ADDRESSEES	: Owners and operators ABC Customer Care and Parts Source
VEHICLE MODEL	: CX35 with Cummins L9 engine
MANUAL CHAPTER	: 2.30 Traction engine – exhaust system
BULLETIN TYPE	: Field Change Program
DATE	: February 21st, 2019
SUBJECT	: To change Diesel Exhaust Fluid (DEF) hose between pump and injector unit
TERMS & CONDITIONS	: Refer to the warranty section further in this Bulletin

Figure 1: View in compartment behind rearmost exterior access door at the left

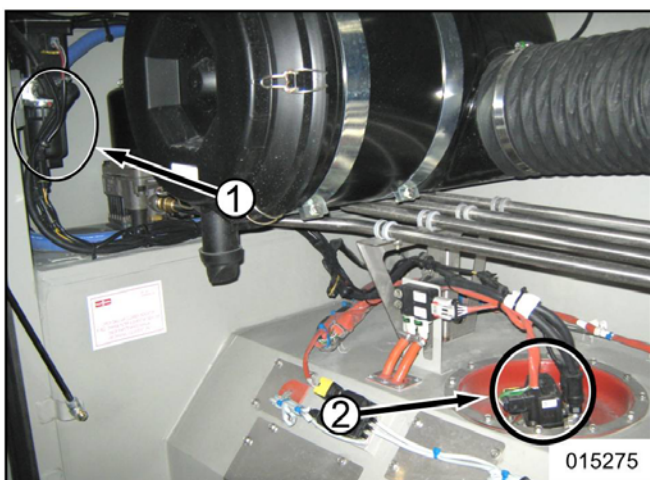
On the vehicles affected by this service bulletin, there is a risk that the heated DEF hose between pump and injector unit overheats. Investigation has shown that the heat generated by the electric current flowing in the heating wire of the DEF hose could damage the line if the DEF flow is low.

To address this issue, Van Hool is conducting a Field Change Program to change the affected DEF hose by an improved hose. We also ask to change the 15A circuit breaker protecting the electric circuit of the heated DEF hose by an 8A type.

- 1. DEF pump
- 2. Injector unit
